# UNITED STATES PATENT AND TRADEMARK OFFICE

10/045,416

David J. Kunst

## Office Action Summary

Fig. 5. (US 5,059,916) ( $I_r$ ,  $I_a$ ,  $I_c$  and corresponding arrows have been added by examiner for indicating current flow).

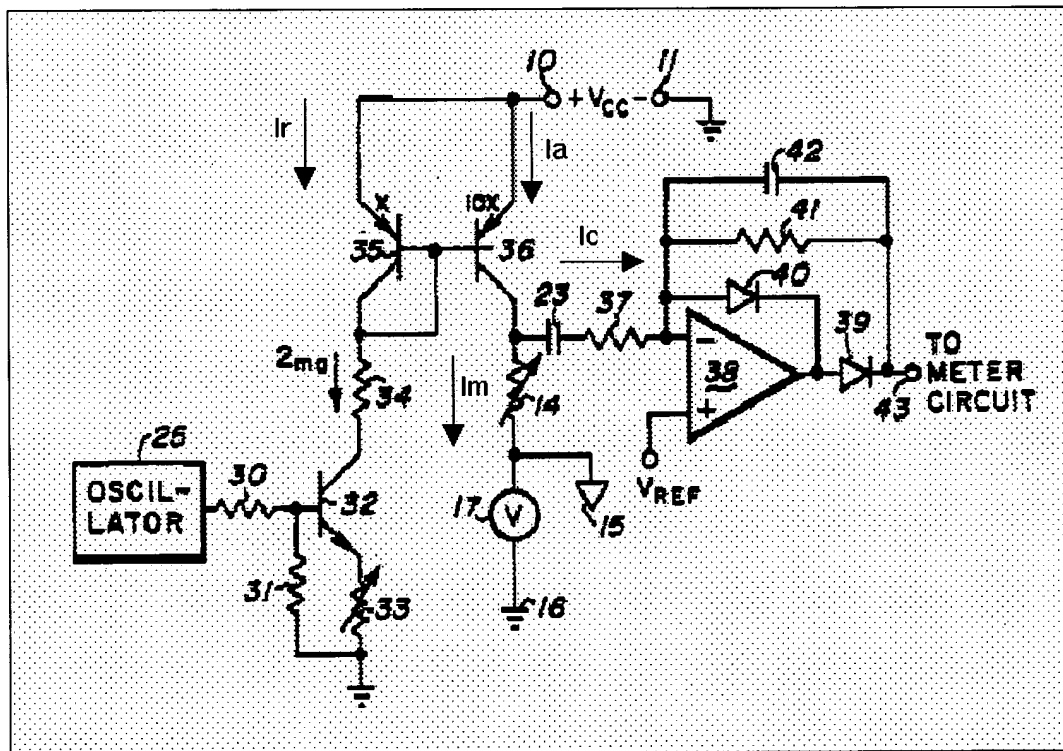
Re claim 1, (as best understood), Johnson discloses apparatus for determining a state of a measurable circuit element 14 having a plurality of states and a different impedance (variable resistance) in each state comprising a replicate circuit (35,34,32,33) configured to generate an adjustable test current and a trim determination circuit (36,14) coupled with the replication circuit for receiving the adjustable test current the trim determination circuit including the measurable circuit element 14 configured to compare ( $I_a - I_m$ ) the adjustable test current ( $I_a$ ) to a current through the measurable circuit element ( $I_m$ ) to indicate at least one of the states (resistance) of the measurable circuit element 14 (column 3 lines 50-64)(please see Fig. 5 shown below).

12. In response to applicant's arguments regarding rejection under 35 U.S.C. 102(b) of claims 1-9, that Johnson fails to teach a replicate circuit including a replicate circuit element configured to generate an adjustable test current indicative of one of the plurality of states, and that Johnson does not disclose generating an adjustable test current that is indicative of a state of a measurable device. Claims are given their broadest reasonable interpretation consistent with the supporting description (MPEP 2111). In the instant case, Johnson discloses a circuit (35,34,32,33) which is broadly interpreted as a replicate circuit configured to generate an adjustable test current ( $I_a$ )(illustrated by examiner in the Figure shown below) and a circuit (36,14) broadly interpreted as a trim determination circuit coupled with the replication circuit for receiving the adjustable test current, the trim determination circuit including the measurable circuit element 14, and utilizing the adjustable test current to indicate at least one of the states (resistance) of the measurable circuit element 14 (column 3 lines 50-64)(Fig. 5).

element. Applicant is referred to the Figure shown below wherein a trim determination circuit configured to compare the adjustable test current to a current through the measurable circuit element and indicating at least one of the states of the measurable circuit element is shown. As stated above the circuit (36,14) is broadly interpreted as the trim determination circuit which is coupled with the replication circuit (35,34,32,33) for receiving the adjustable test current ( $I_a$ ), and based upon a comparison of the adjustable test current ( $I_a$ ) to a current through the measurable circuit element ( $I_m$ ) a state of the measurable circuit element 14 is determined. The state of the measurable circuit element 14 would be determined by knowing its resistance as measured by the meter circuit 43 since the input signal ( $I_c$ ) to the inverting input (-) of Opamp 38 is a function of the current ( $I_m$ ) passed through the measurable circuit element 14 as determined from the following relation ( $I_c = I_a - I_m$ ). Therefore, Johnson discloses measurable circuit element 14 configured to compare ( $I_a - I_m$ ) the adjustable test current ( $I_a$ ) to a current through the measurable circuit element ( $I_m$ ).
